# CITY OF GARDEN CITY

**STAFF REPORT**

**File Number:** SUBFY2022 - 0002, Honcik Townhomes  
**For:** Final Plat and Planned Unit Development  
 A 7-lot residential subdivision  
**Location:** 3900 N. Reed Street  
**Applicant:** Jeff Hatch  
**City Council Preliminary Plat Approval:** October 24, 2022  
**Report Date:** Date finalized for CC November 12, 2024

PROPOSED SITE PLAN

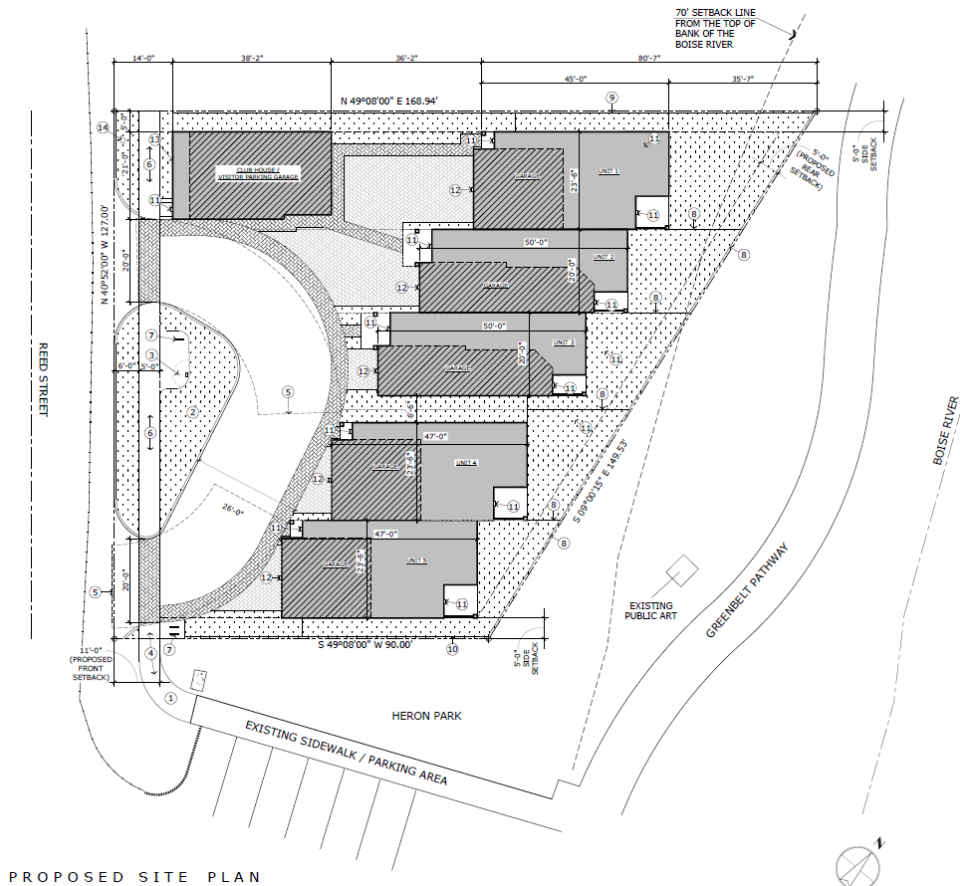
This application is not clearly in substantial compliance with the approved preliminary plat. The application proposes removal of a pathway that was a provision required during the preliminary plat to find the preliminary plat in compliance.

The plans were updated to address these comments by enhancing the public pathway through the development. The pathway has now been removed in its entirety and replaced with vegetation. The applicant is proposing that the public utilize the city's Heron Park interior sidewalk. While this is sufficient for public access to the Greenbelt, it removes the component of the subdivision that was included to have the subdivision address Reed Street.

Because of the removal of the pathway, not all of the conditions of approval will be able to be adhered to. For this reason, the planning official has not found that the final plat is in substantial compliance with preliminary plat. The planning official notes that the matter should be remanded to the Design Review Consultants to address this issue.
